SYDNEY CENTRAL PLANNING PANEL (SCPP)

Panel Reference	2016SYE108 DA
DA Number	DA201600434
LGA	Inner West Council
Proposed Development	Construction of a mixed use development through the adaptive reuse and associated alterations of former hospital building(s) to provide a community hub, comprising a public library, pavilion, a residential building, and construction of three (3) new residential flat buildings including car parking, landscaping and associated works.
Street Address	182-186 Livingstone Road & 313-319 Marrickville Road, Marrickville
Applicant/Owner	Mirvac Projects Pty Limited / Inner West Council
Date of DA lodgement	26 August 2016
Number of Submissions	60
Recommendation	Approval subject to conditions
Regional Development Criteria (Schedule 4A of the EP&A Act)	Capital Investment Value (CIV) exceeds \$5 million.
List of all relevant s79C(1)(a) matters	<p>The following State and Local government legislative framework applies to the development:</p> <ul style="list-style-type: none"> • State Environmental Planning Policy (State and Regional Development) 2011 • State Environmental Planning Policy No 55 - Remediation of Land • State Environmental Planning Policy No 65 – Desig

Figure 30: Extract from Library Roof Detail prepared by BVN

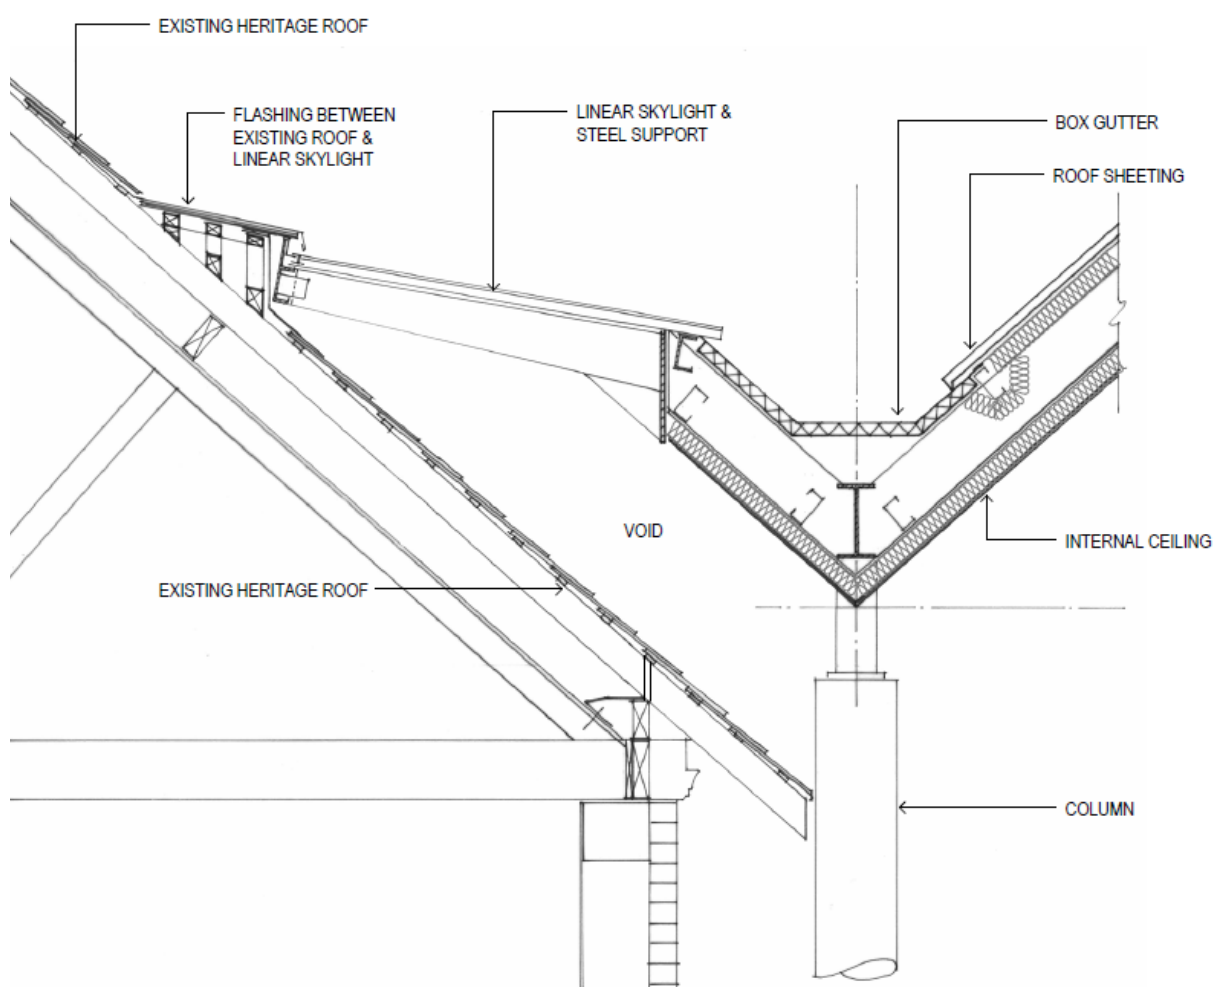
6. *It would be beneficial if the design of the library roof was reconsidered to provide valley gutters at a maximum gradient of 1:100 to improve drainage and reduce need for maintenance.*

The design of the skylight connection detail on the western side has been refined. Additional information has been provided by the Library architects as well as the applicant's hydraulic engineer which details that required waterproofing will be provided, and that the proposed roof gutter design has been undertaken in accordance with requirements as noted in the NCC and AS3500 which is typically used for all roof water drainage systems. Additionally, the design will allow views of the Heritage building details internally.

The amended design addresses the AEP concerns.

Figure 31: Extract of Drawing SK0022 – “Building A Internal Corner Screening”

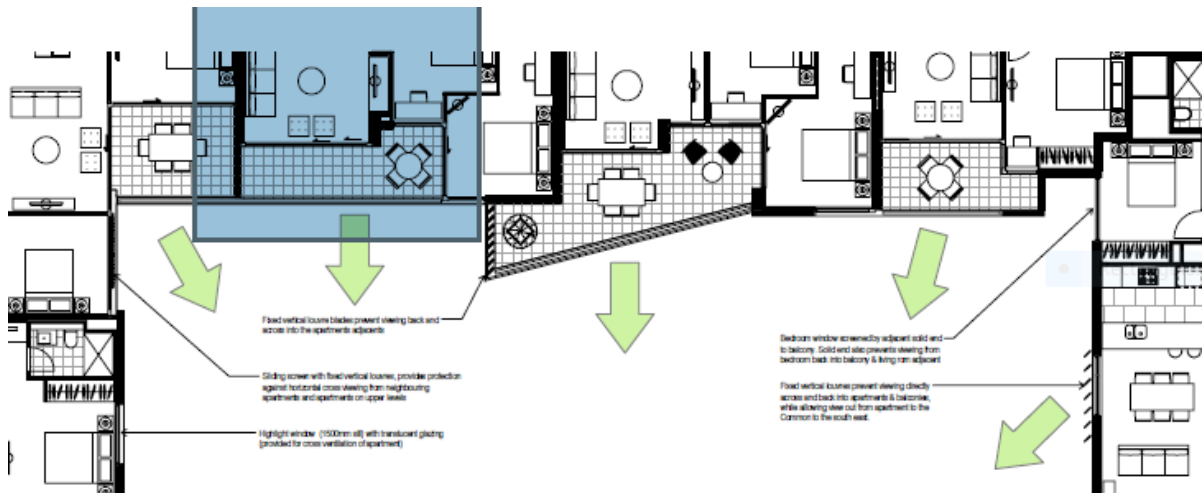
7. *The balconies/bedrooms where Buildings A1 and A2 turn the corner create dwelling proximity and separation issues that are difficult to resolve.*

The applicant has provided detailed drawing of the relationship between Buildings A1 and A2 where they "turn the corner". The drawing demonstrates that attention has been given to the orientation of balconies and openings as well as the configuration of internal layouts that when combined with proposed fixed and operable vertical louvered blades, an acceptable level of visual privacy will be achieved – refer to Figure 31 which is an extract of Drawing SK0022.

Figure 32: Extract from drawing SK0021 submitted by the applicant

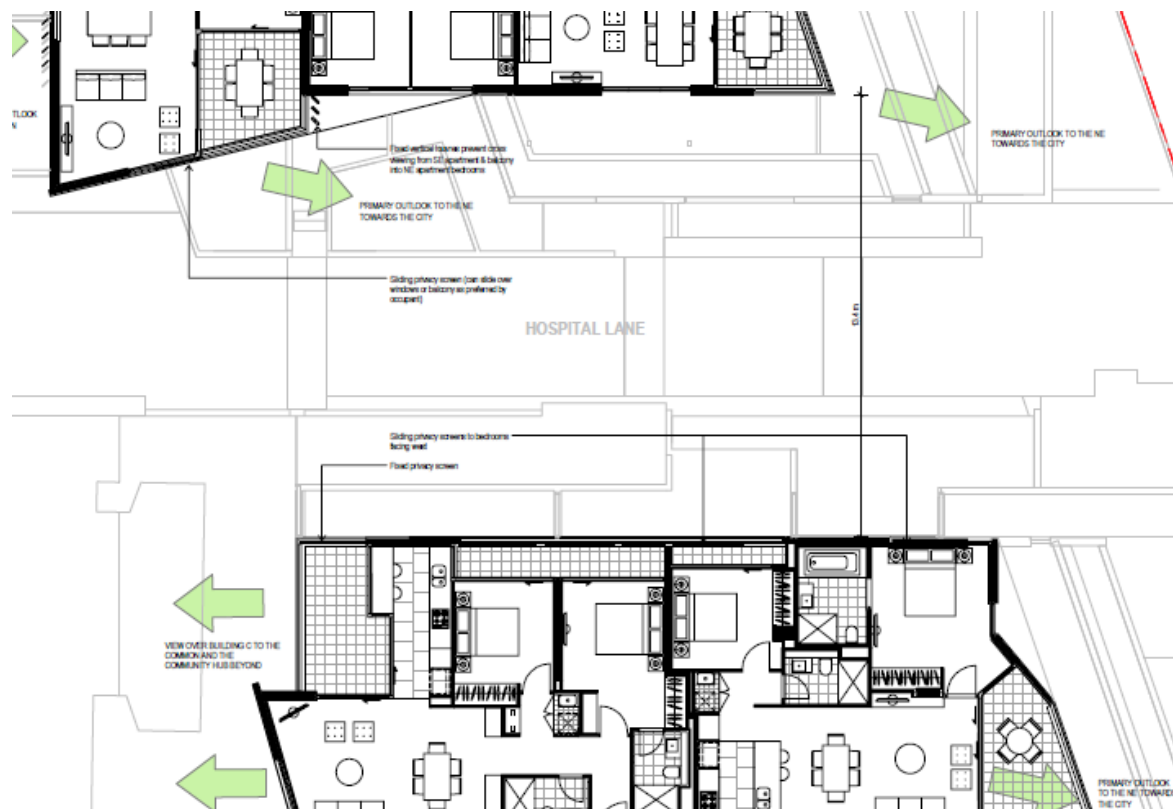
The proposal is demonstrated in the drawing titled “Building Separation Typical Plan for Levels 03-08” (SK0021), which was submitted by the applicant in response to a request for greater details relating to visual privacy and building separation raised by Council and the AEP. An extract of the drawing is provided below in Figure 32. Additionally, a document titled “DA201600434 Design Response May 2017” included an illustration and analysis of the building separation between Building A2 and Building B (refer to Figure 33).

The design of the apartment layouts and the orientation assist in providing privacy at this interface by directing the principal outlook away from neighbouring apartments, as demonstrated in the submitted drawing SK0021.

Figure 34: Extract from “Building B Context Section with Lilydale Street neighbours” drawing DA-R30

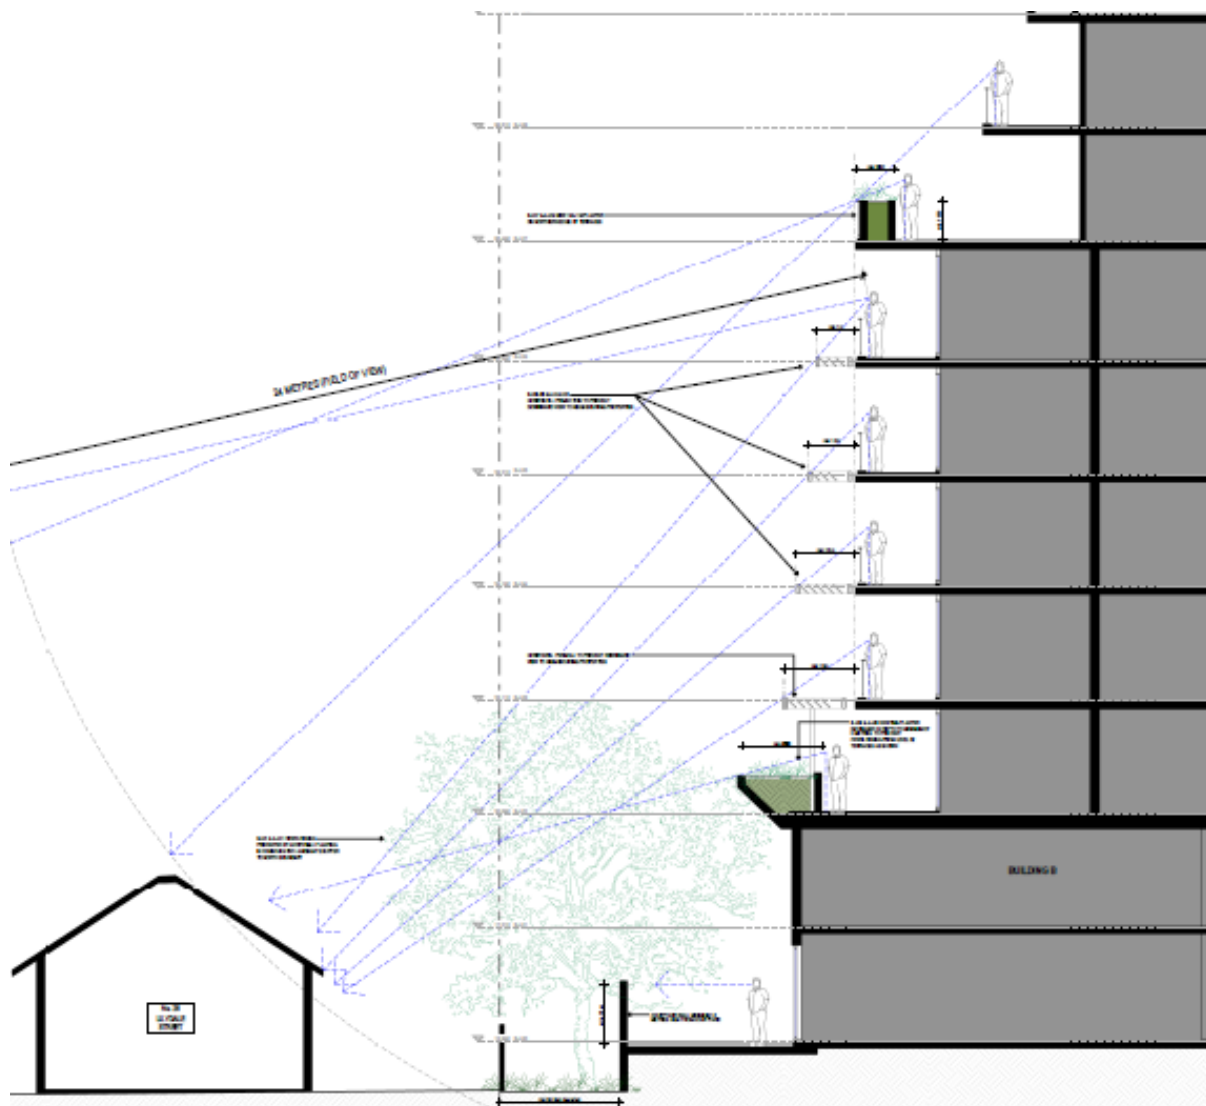
Notwithstanding, the applicant has amended the design of the northern elevations of Buildings A2 and B, and the landscape treatment adjacent to the northern boundary in response to a request by the assessment officer, to mitigate overlooking opportunities towards the low density residential properties to the north, particularly to the rear yards and south facing openings of 28 Lilydale Street and 172 Livingstone Road.

The amendments also include the installation of horizontal louvres to the northern edge of the building at most levels, and the inclusion of raised planter beds on the levels that do not have horizontal louvres. A reduction in the size of north facing bedroom balconies to no more than 1.2m in depth has also occurred.

The result of the amendments is that direct overlooking from the balconies and living rooms of the north facing apartments in Buildings A2 and B towards the low density residential properties to the north (particularly the properties at 28 Lilydale Street and 172 Livingstone Road) have been mitigated to an acceptable level. This is demonstrated in the section drawing DA-R30 (refer to extract below in Figure 34).

The amended design is considered to mitigate overlooking from the proposed buildings towards the low density dwellings to the north to an acceptable level and satisfy the Objective at Part 3F-1 of the ADG.

Figure 36: Extract from Section Drawing DA-R24

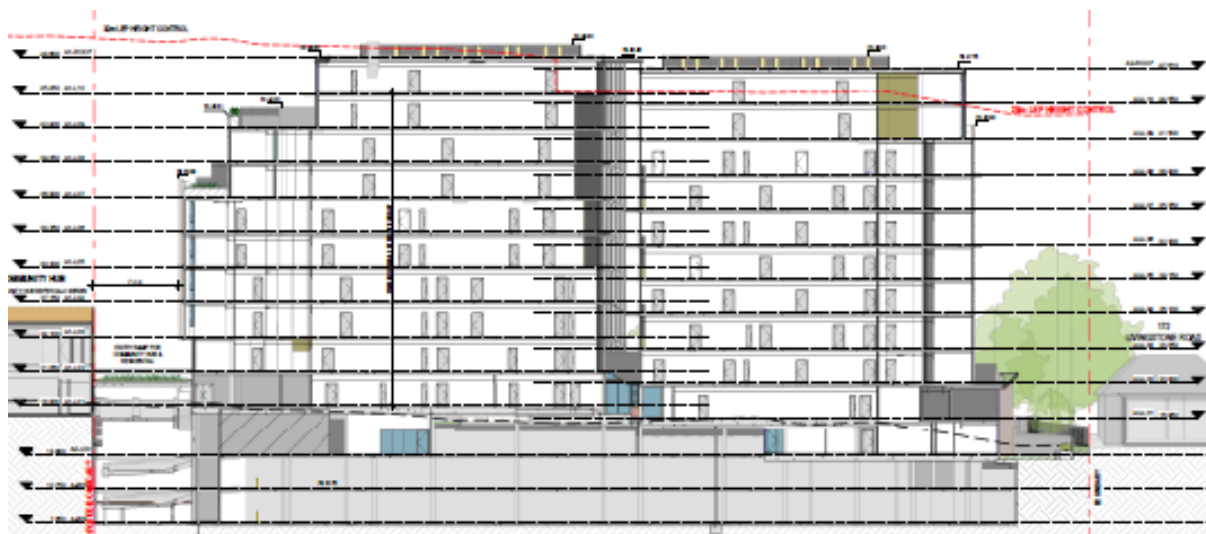
The area of non-compliance relates to Building A2 and the northern portion of Building A1, with both buildings having a maximum height of 32.8m.

Figure 36 is an extract from a Section drawing submitted with the DA and demonstrates the area and level of non-compliance.
